Adastral Park, Ipswich : Offsite Highway Mitigation to A12 / Barrack Square / Eagle Way Roundabout and Gloster Road / Barrack Square Priority Junction

Technical Note : Designer's Response to Road Safety Audits at Stage 1

14th September 2017

Stage 1 Road Safety Audit

UNTIL TECHNICAL APPROVAL HAS BEEN OBTAINED FROM THE RELEVANT LOCAL AUTHORITIES, IT SHOULD BE UNDERSTOOD THAT ALL DRAWINGS ARE ISSUED AS PRELIMINARY AND NOT FOR CONSTRUCTION. SHOULD THE CONTRACTOR COMMENCE SITE WORK PRIOR TO APPROVAL BEING GIVEN, IT IS ENTIRELY AT HIS OWN RISK.

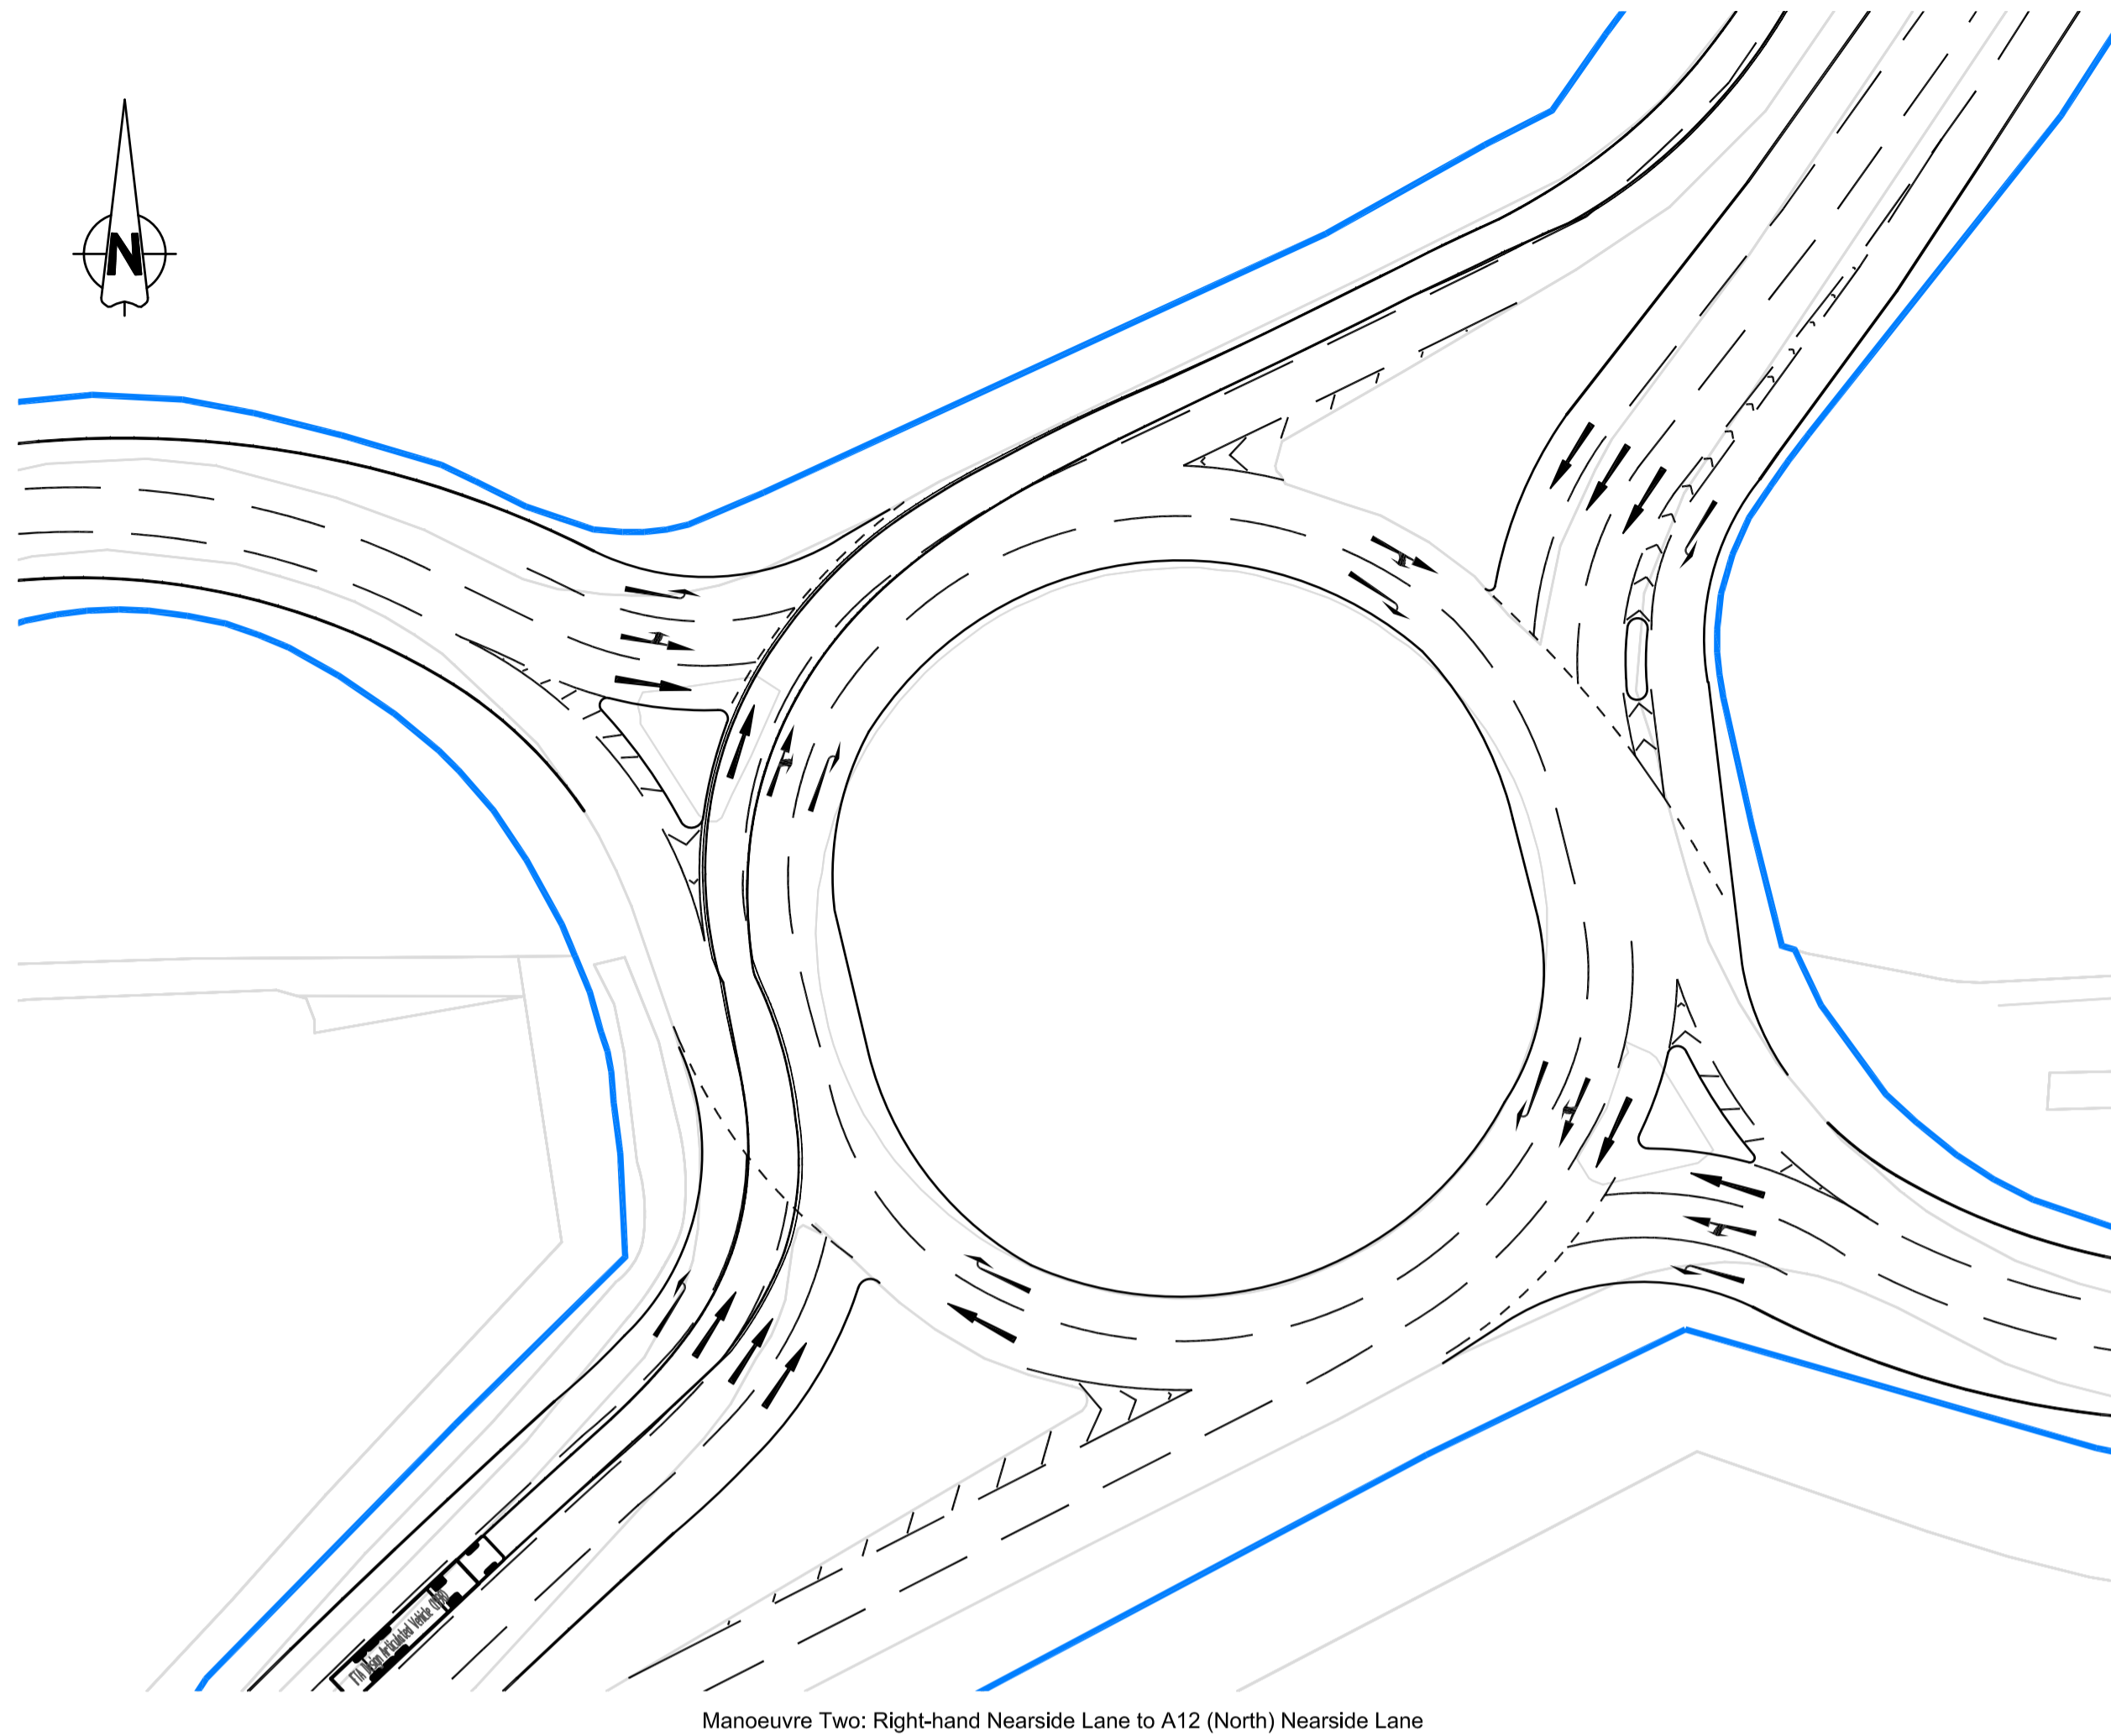
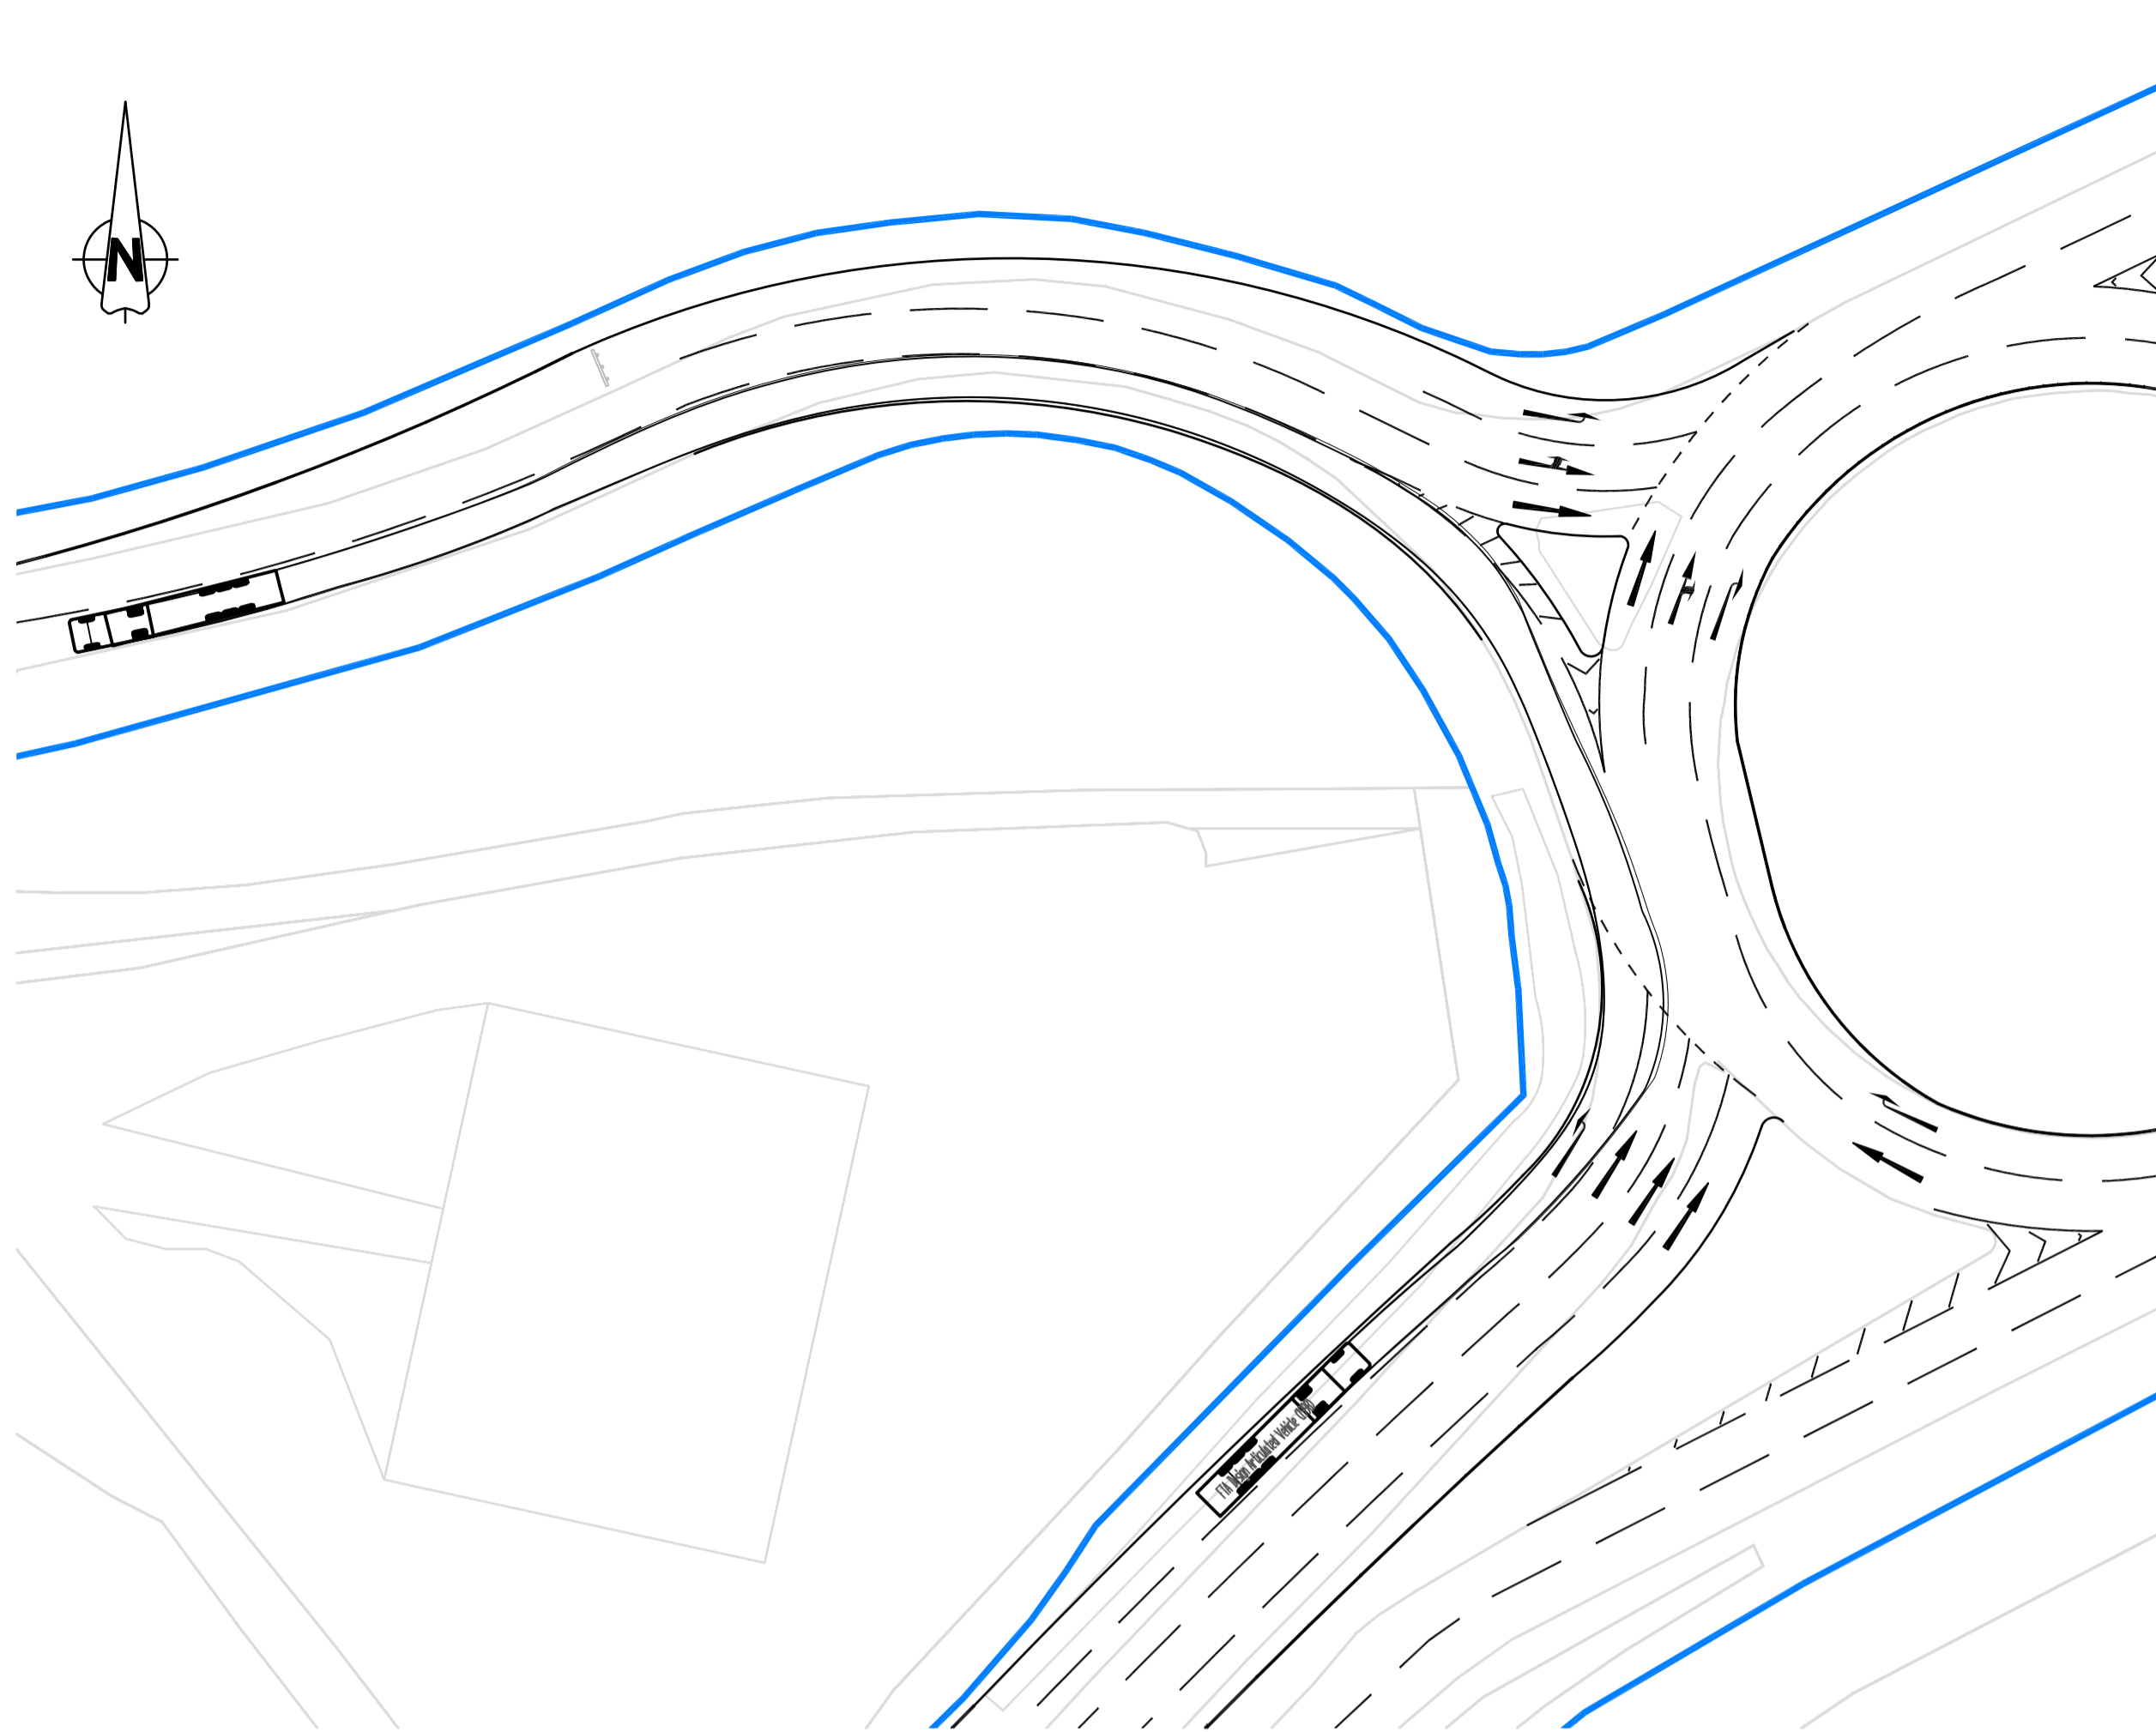
Summary: Risk of sideswipe accidents. The layout indicates a very narrow centre lane on the southeast quadrant and a risk of the nearside lane not being wide enough for the radius required to be traversed on the southwest quadrant from the A12 southern arm.

Recommendation: Carry out swept path analysis to ensure that all vehicles can travel within the intended lanes and make adjustments as required.

BCL Response: *Swept path analysis has been carried out for all the possible manoeuvres across the south-east and south-west quadrants of the roundabout. These are indicated on drawings 10391-HL-36 and 10391-HL-37 in Appendix B.*
